Appl. No. 10/688,185  
Amdt. Dated November 26, 2007  
Reply to Office Action of September 12, 2007

### REMARKS/ARGUMENTS

FIG. 1

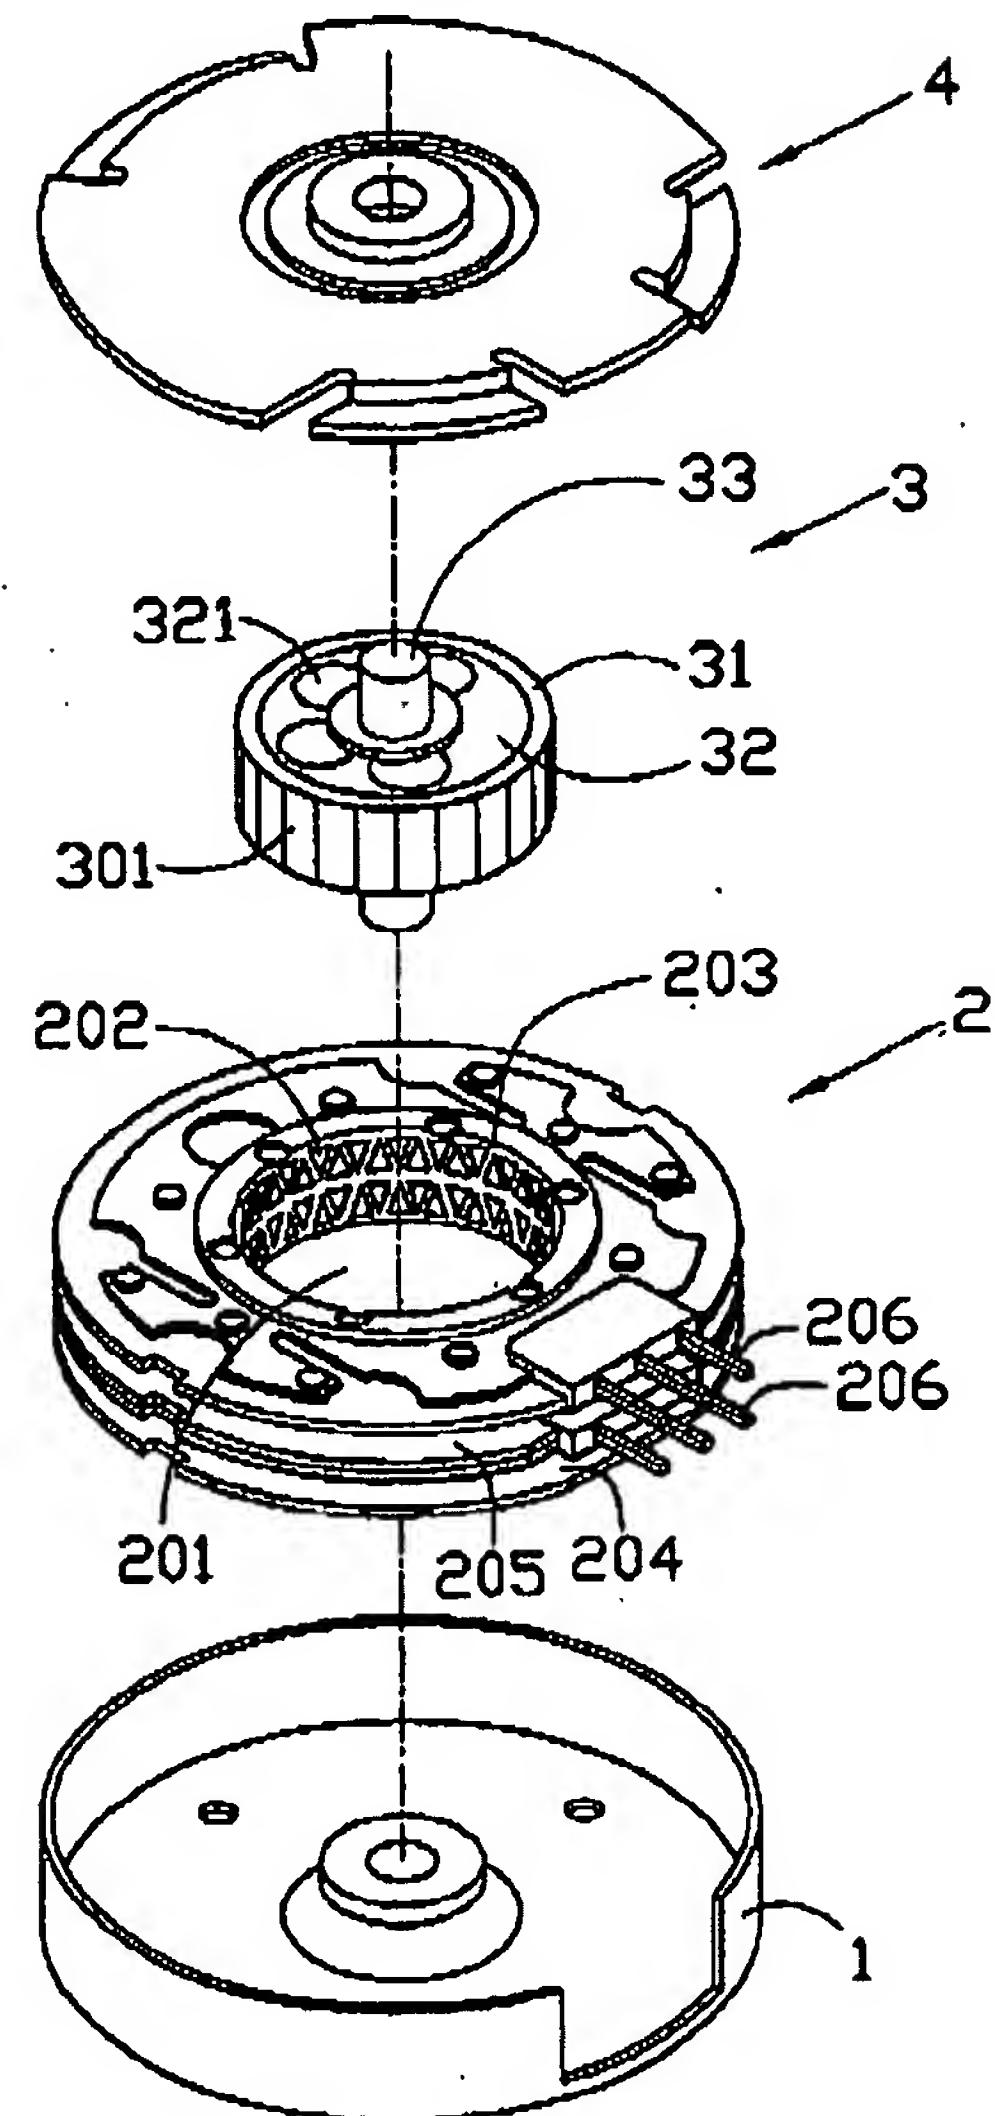
The drawings are objected to by the Draftsperson under 37 CFR 1.84(l) and 37 CFR 1.84(p). Furthermore, the numerical label (4) for the upper housing is missing from Fig. 1.

In response to the drawing objections, applicant has amended Figs. 1-2 and submits Replacement Sheet to replace the originally filed drawings. Every lines, numbers and legends in the drawings of the Replacement Sheet have good quality and are well defined, plain and legible. Furthermore, the reference character "4" has been added to Fig. 1 to show the upper housing. Accordingly, the drawing objections are overcome.
